## **UPDATE SHEET**

### PLANNING COMMITTEE – 01 December 2015

#### MAIN REPORT

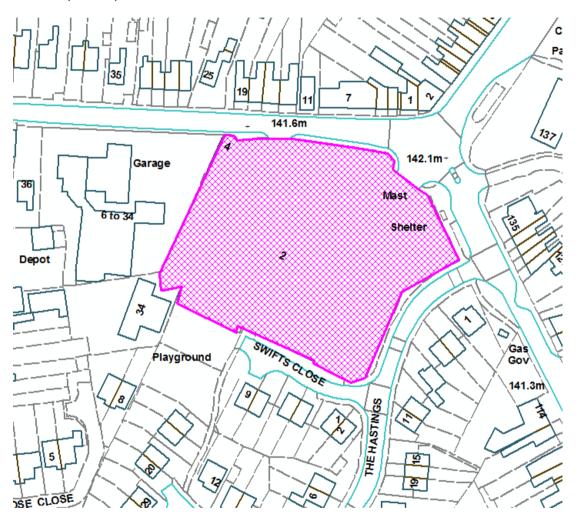
The indicative map provided on page 45 of the Committee Report is incorrect as it does not include the residential property which is proposed to be demolished. An accurate site location plan is provided below:
